<b>Subject:</b>  <p style="text-align: center;"><b>IDLE FLUCTUATION/ENGINE VIBRATION</b></p>	<b>Bulletin No:</b> 01-023/07
	<b>Last Issued:</b> 06/08/2007

2006-2007 Mazda5 vehicles with VINs lower than JM1 CR\*\*\*\* \*\* 133752 (produced before August 4, 2006)

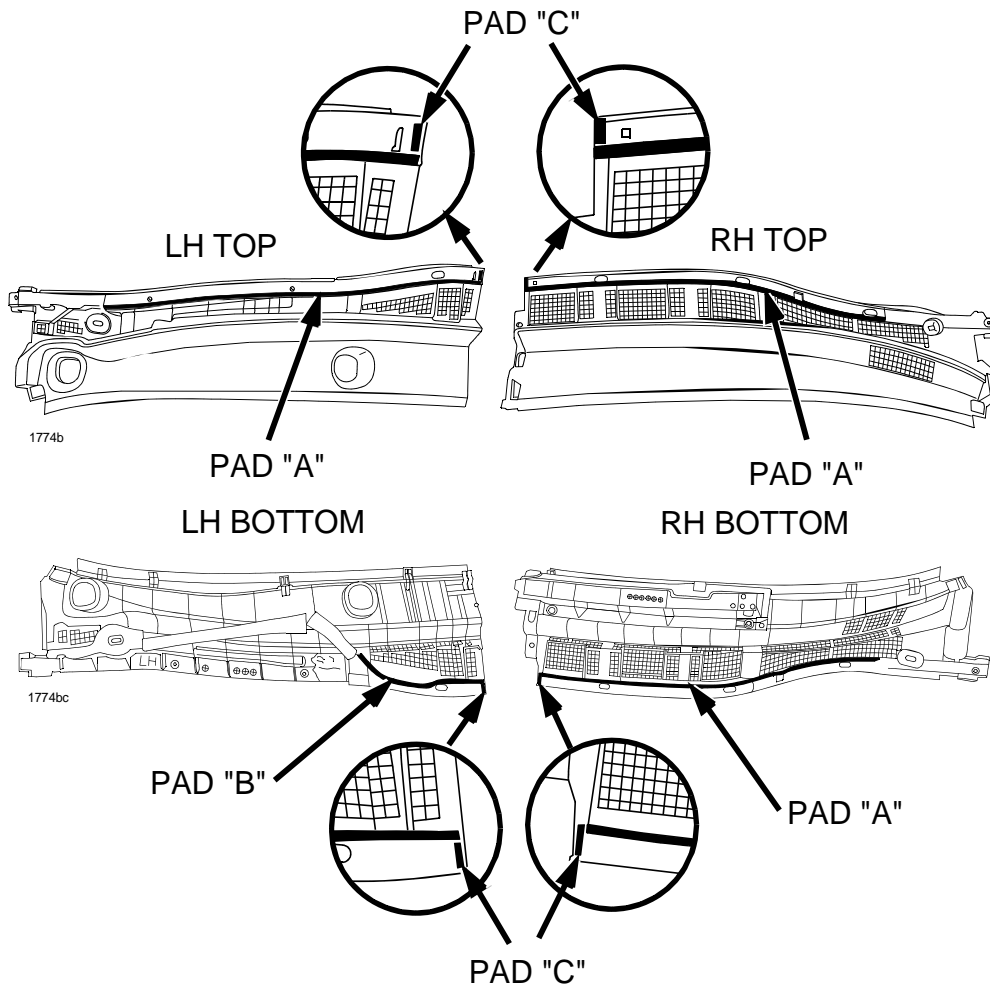
5. Remove the weatherstrip.
6. Remove the fasteners.
7. Remove both left and right cowl grilles by pulling up on the front and then pulling forward.
8. Add pads to the surface and back of the cowl grille as shown.

**NOTE:** Before adding the pads, be sure to clean and degrease the areas where the pads are attached.

Part Number	Description	Qty.	Notes
LFB6-18-100B	Ignition Coil	1	Replace only No. 1 ignition coil
C243-50-795	Pad "A"	3	Size: 560 mm x 5 mm x 3 mm
C253-50-795	Pad "B"	1	Size: 220 mm x 5 mm x 3 mm
C255-50-795	Pad "C"	4	Size: 17 mm x 5 mm x 3 mm
